Release Note

Edgecore EAP102 Release v12.0.0

Document # EAP102-v12.0.0-673-03807931

Enhancement from v11.6.4-1333-0cbc88aa

1.13 DHCP Relay

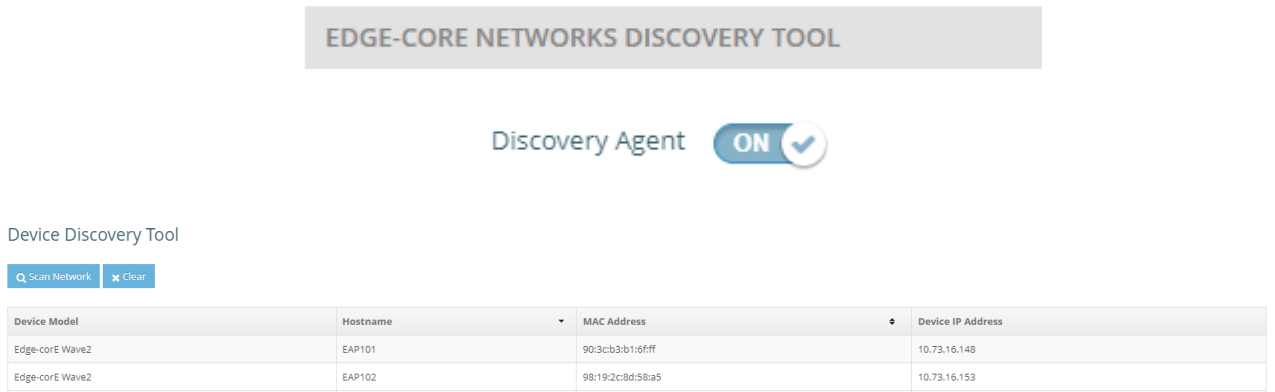
Support DHCP relay on the DHCP relay page of Network.

When enabling DHCP relay server, the DHCP relay server and port must be input. After DHCP relay is enabled, circuit Id can be set on the VLAN settings or LAN settings page. When clients connect to the SSID with DHCP relay enabled, the IP of clients will be obtained by DHCP relay server. The IP range will be distinguished from different remote Id and circuit Id.

1.14 Discovery Tool

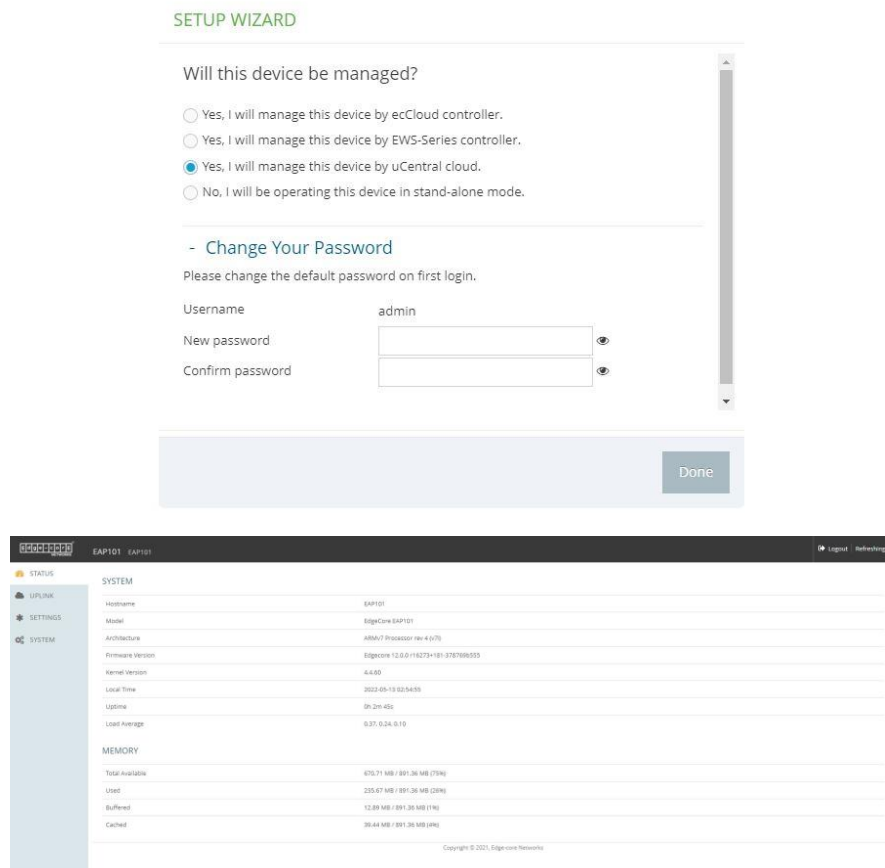
Support Discovery Tool on the Device Discovery page of System. Discovery agent can be disabled on the Services page of System.

Connect Edgecore AP within the same Layer 2 from the ports of the current system, and press the Scan Network button to execute the Device Discovery Tool. The scanning results would be Device Model, Hostname, MAC address, Device IP address, SSIDs, and VLAN ID.
